ADDENDUM NO. 4

Date: **May 13, 2019**
Project: **Ltd. Renovations at Police Annex**
Contract No. P-18-001
3204 Amnicola Highway
Chattanooga, Tennessee 37406

Architect: **Billingsley/Architecture**
Suite 800 Republic Centre
633 Chestnut Street
Chattanooga, Tennessee 37450
(423) 752-0030

SECOND FLOOR HVAC PLAN

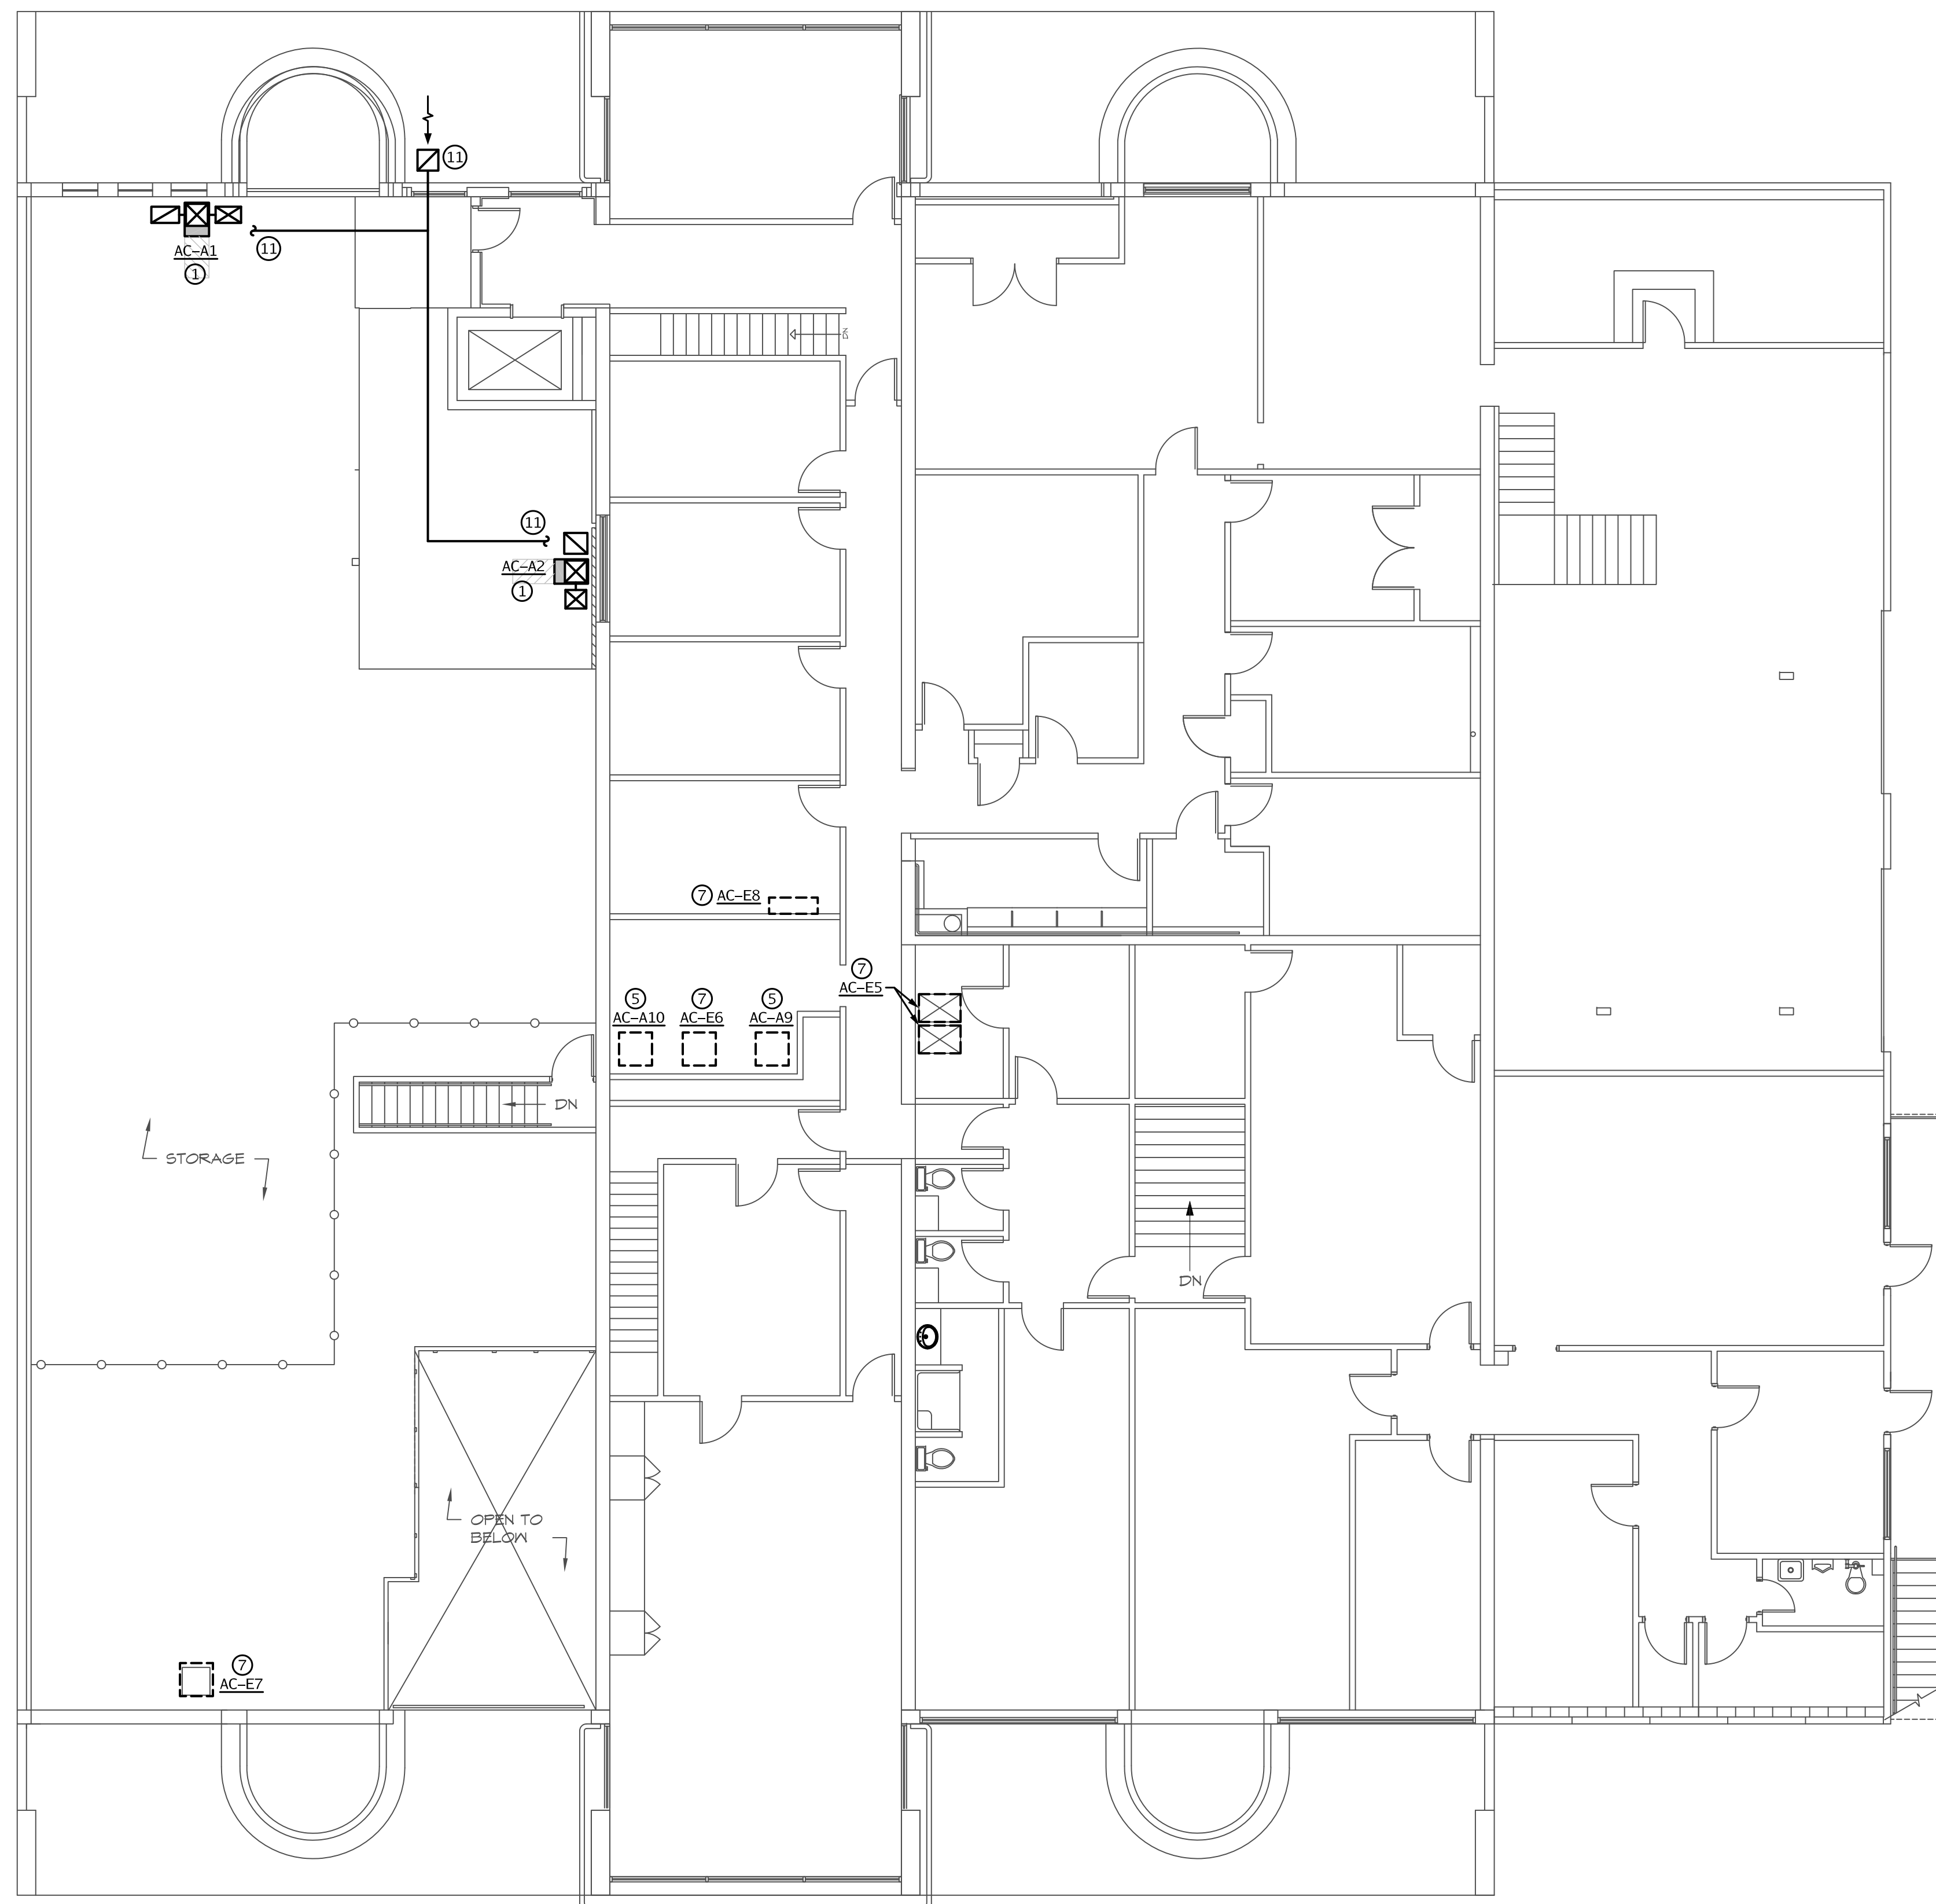
8. Sheet M2.1 Second Floor HVAC Plan
 - H. REVISED SHEET – Issued
 - m. Change Ventilating Fan Schedule.

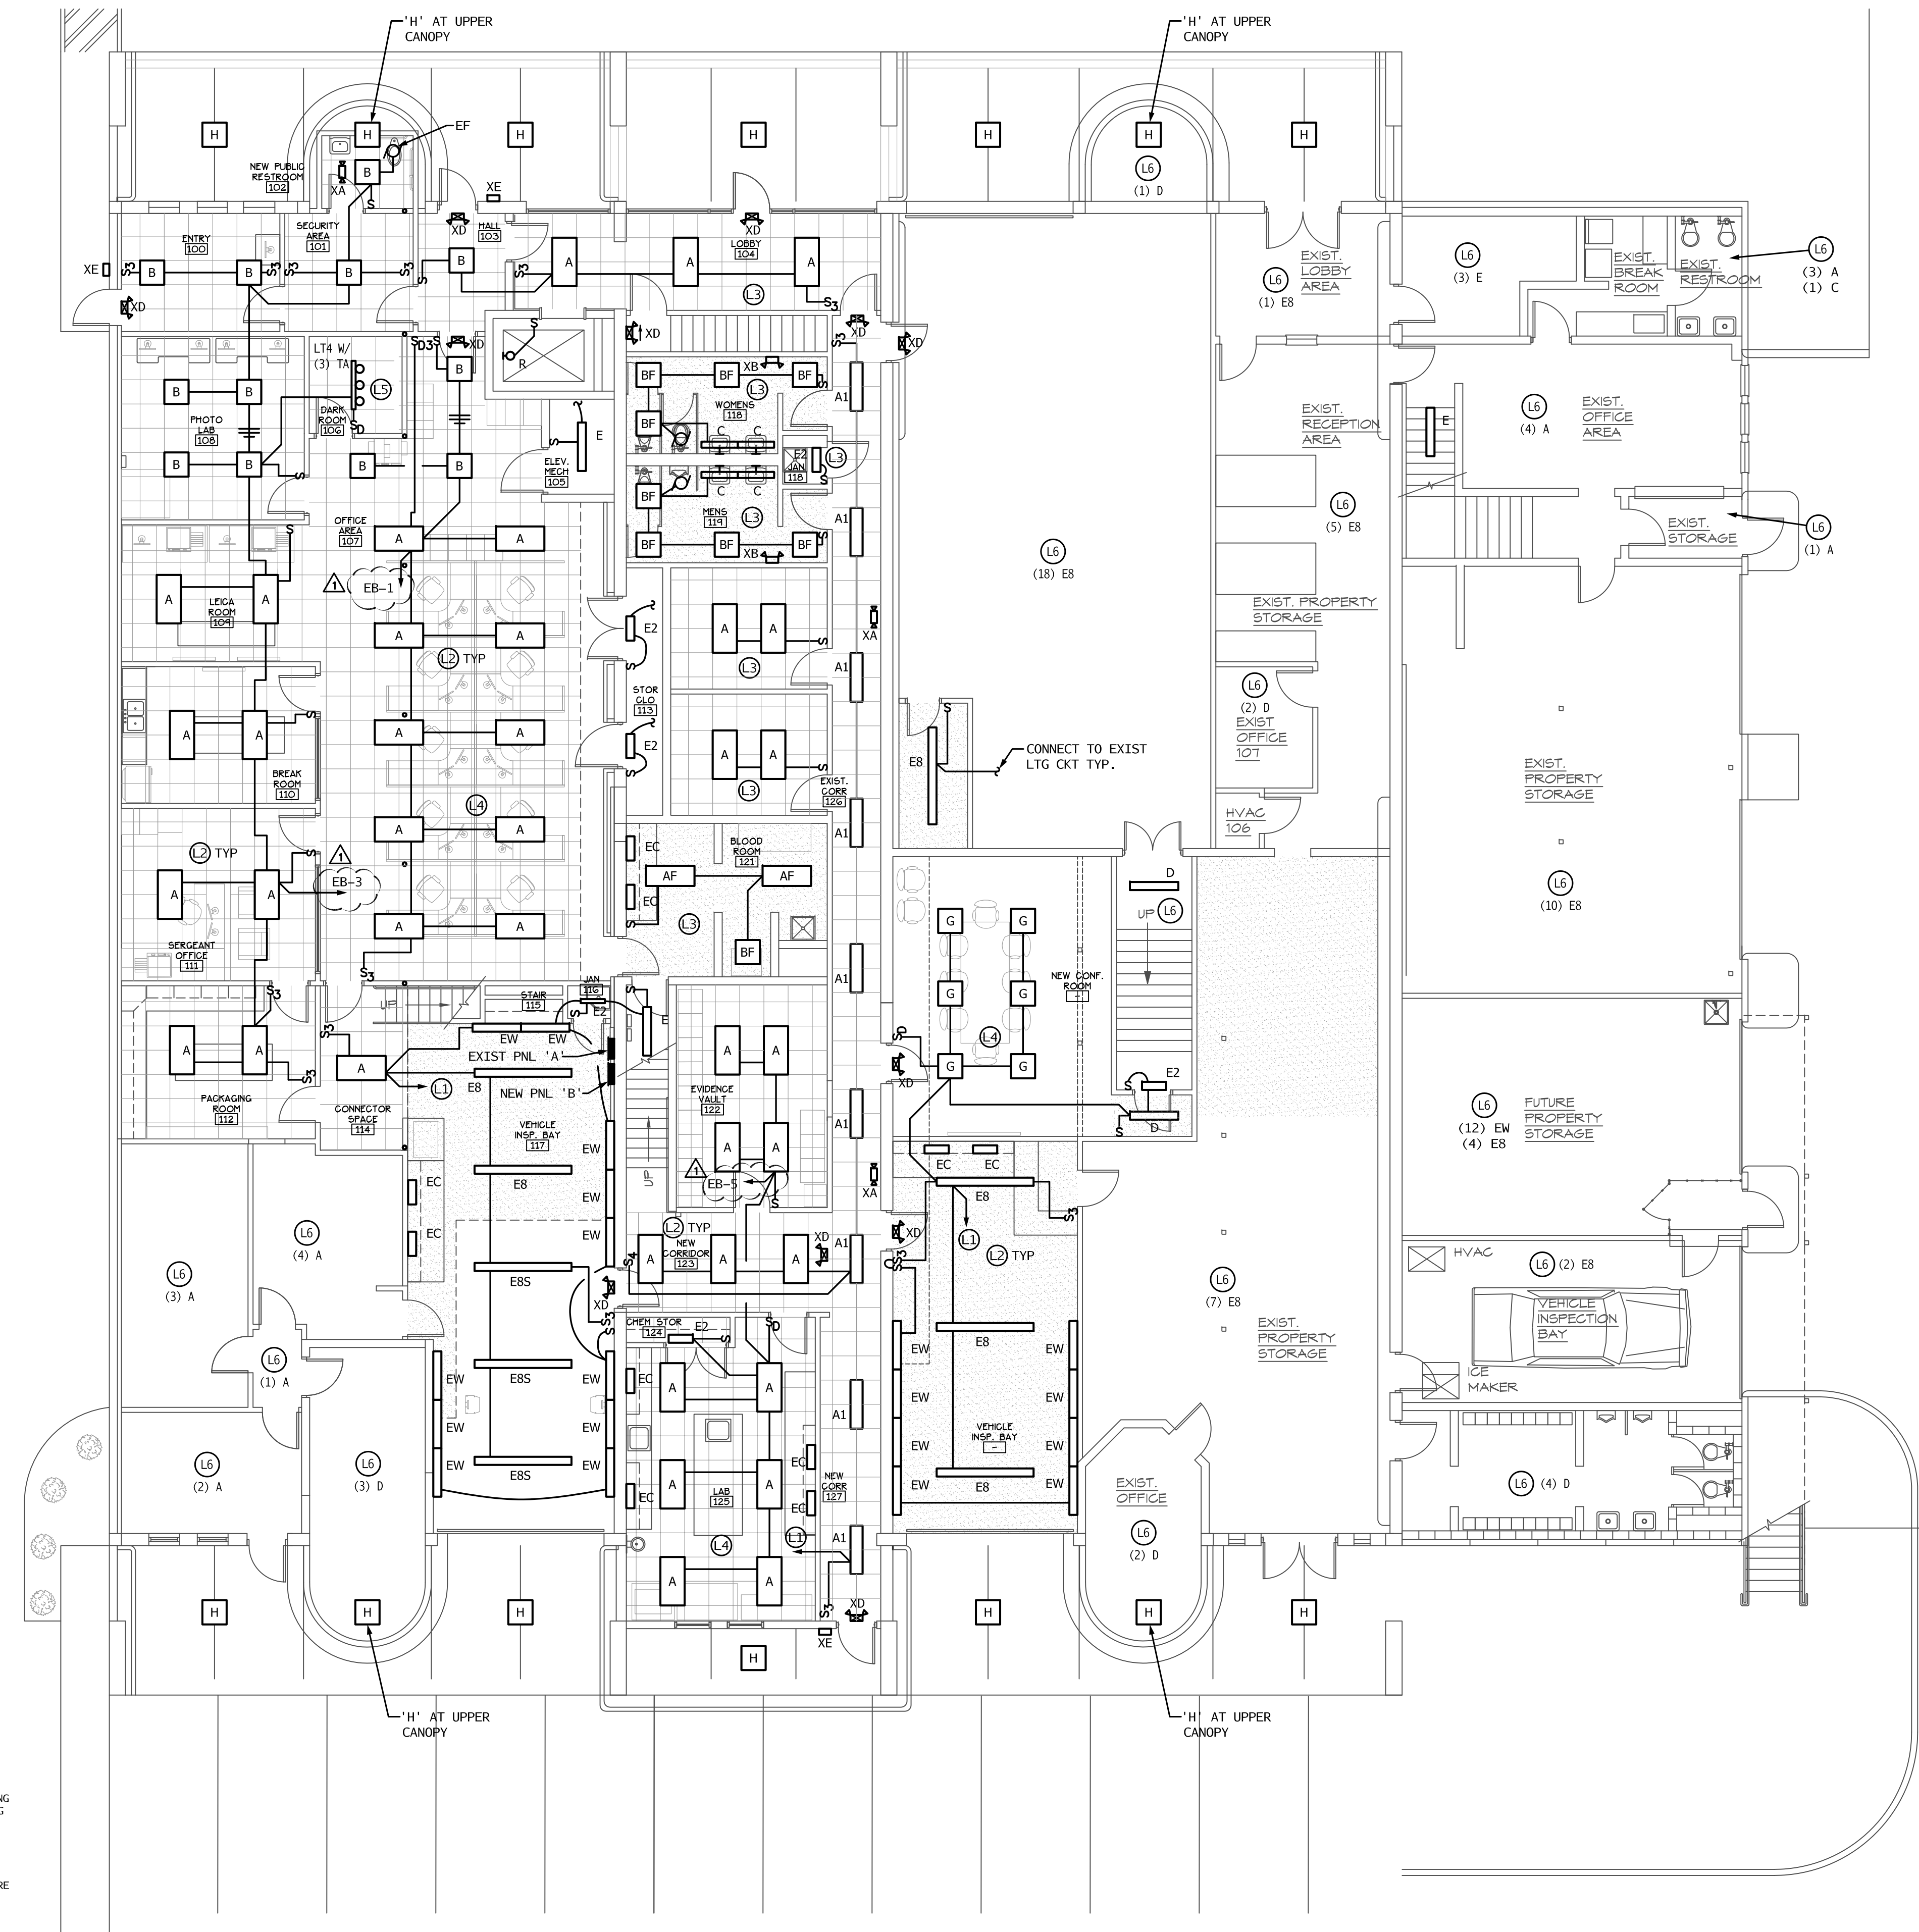
9. Sheet E1.1 Lighting Plan
 - I. REVISED SHEET – Issued
 - n. New EB-1 and EB-3 at Office Area 107.
 - o. New EB-5 at Evidence Vault 122.

Project #: 1850
 2/22/2019
 17-23
 JCP
E2.1

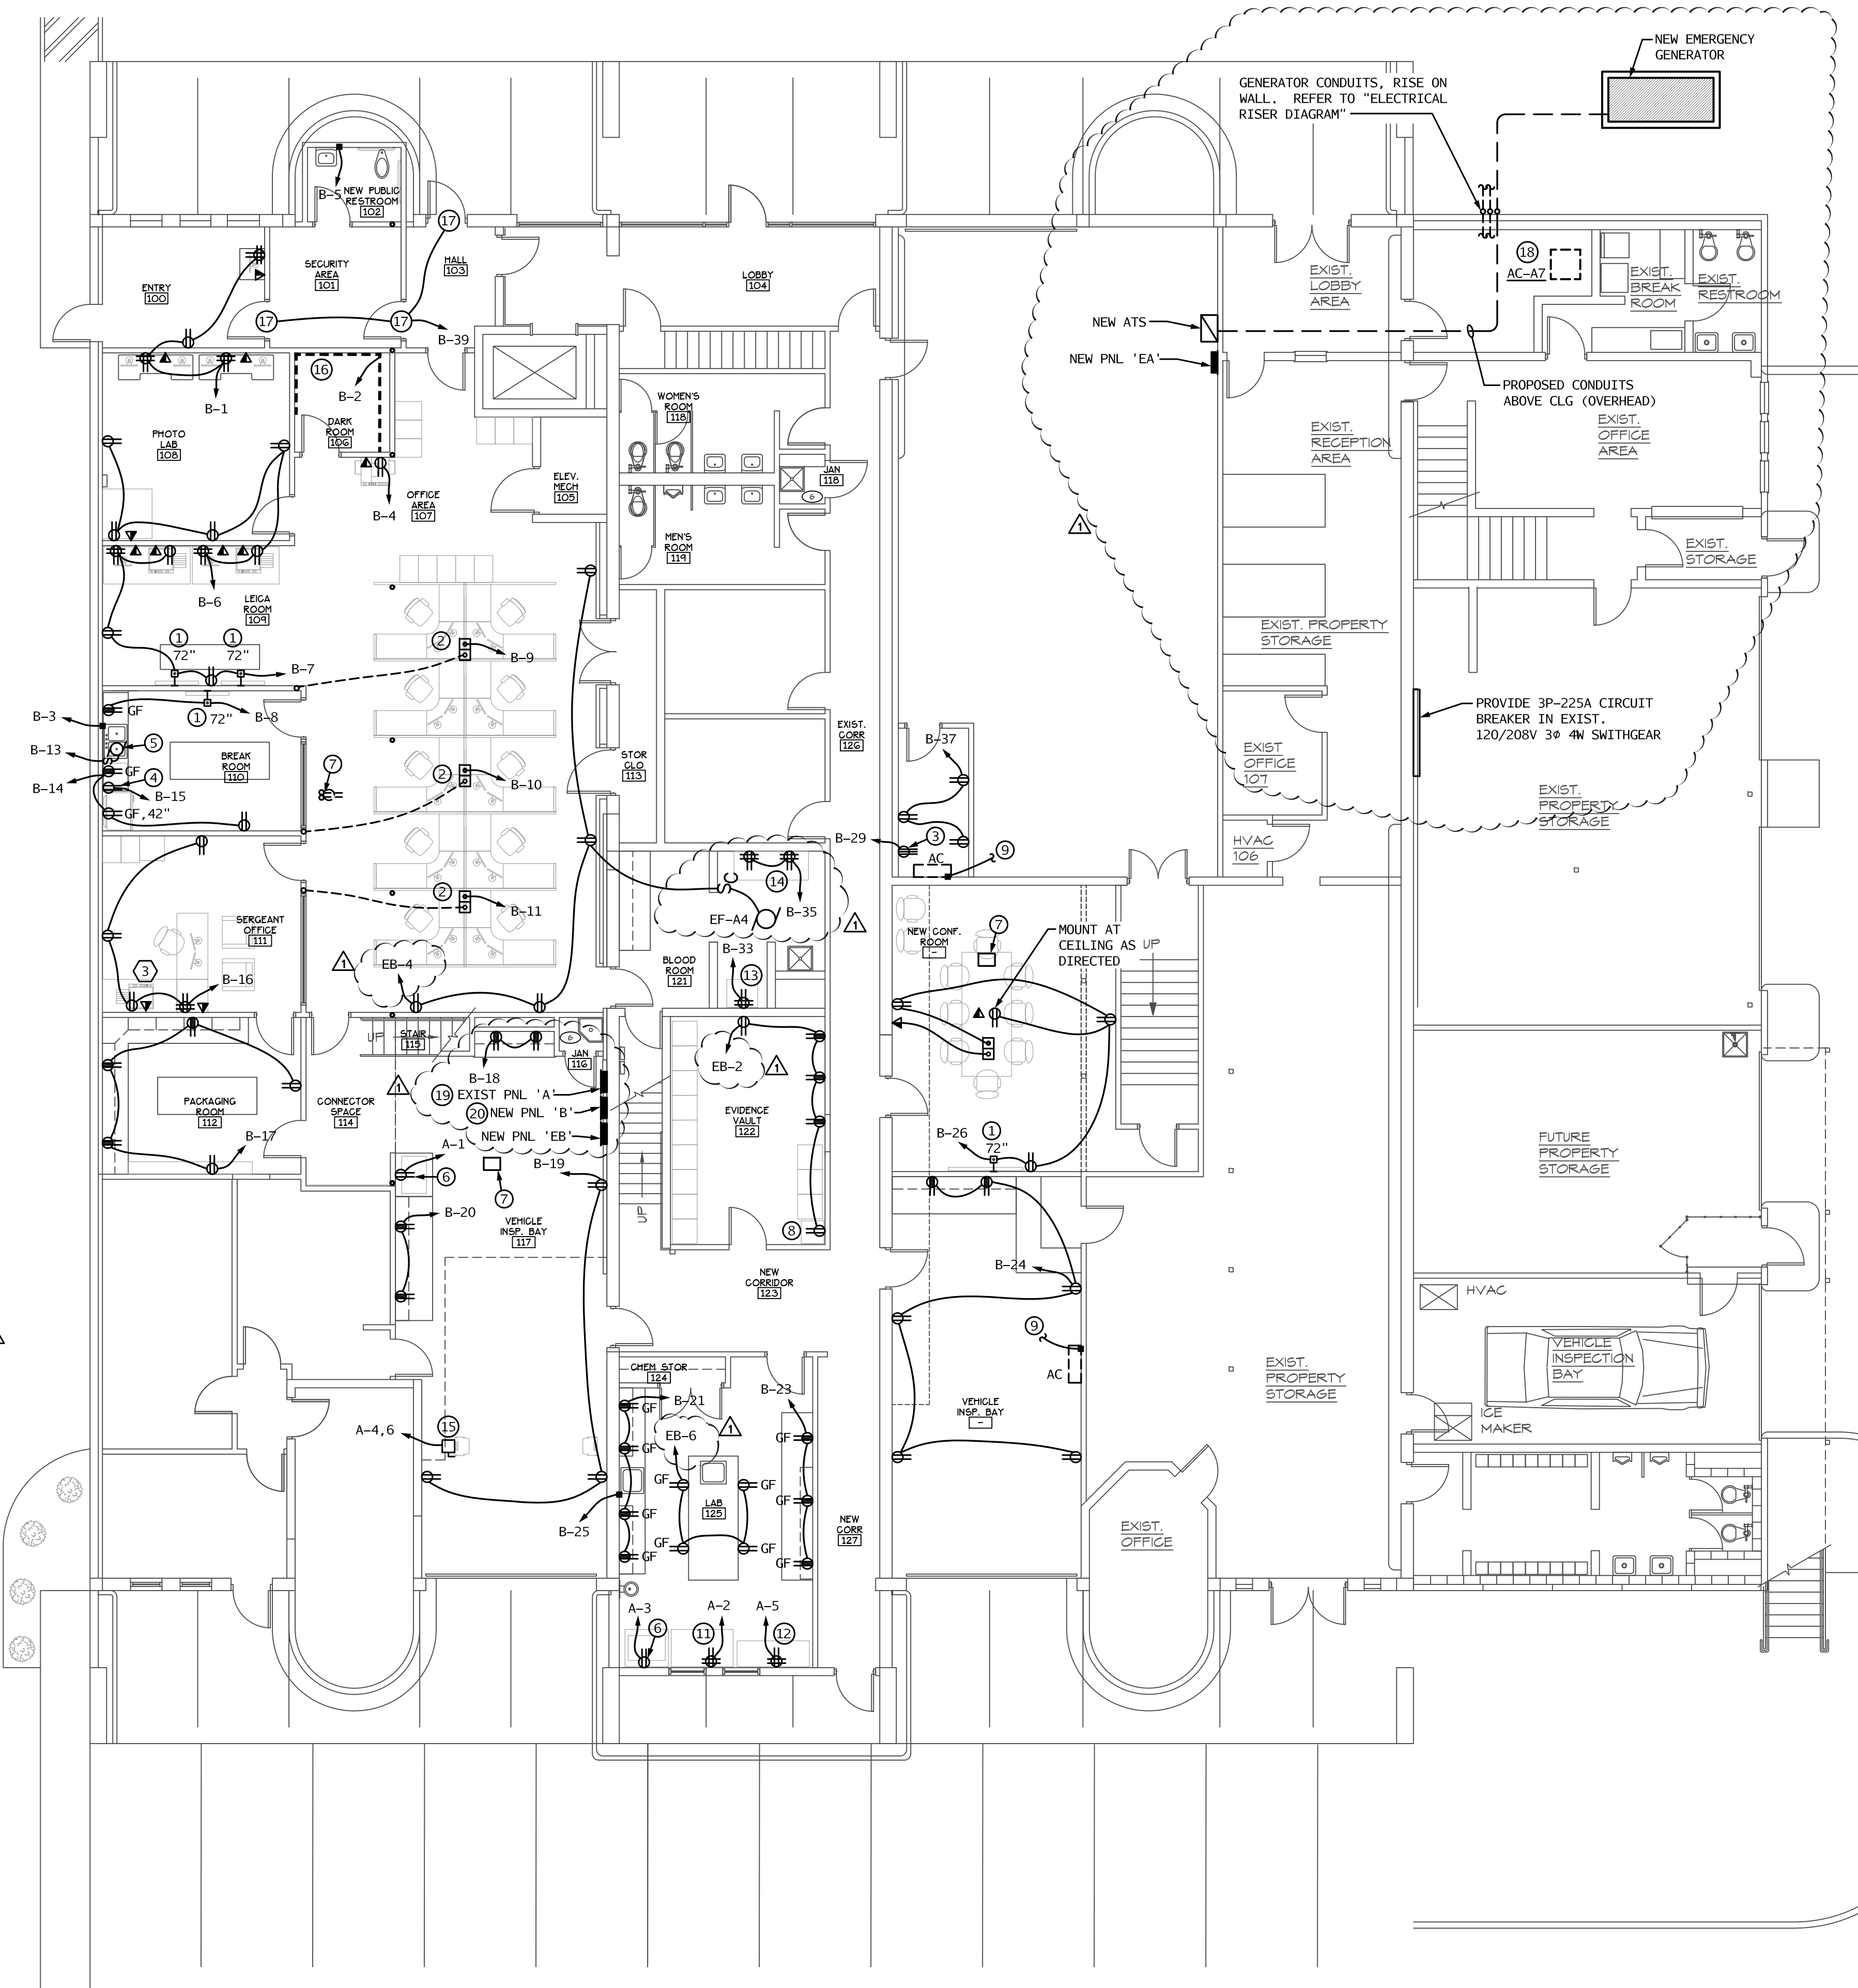
- p. Add Electrical Notes 19 and 20.
- q. Add new emergency generator and notations.
- r. Add EB-4 at Office Area 107.
- s. Add new panel EB at Vehicle Inspection Bay 117.
- t. Add Exhaust Fan at Blood Room 121.
- u. Change to EB-2 at Evidence Vault 122.
- v. Change to EB-6 at Lab 125.
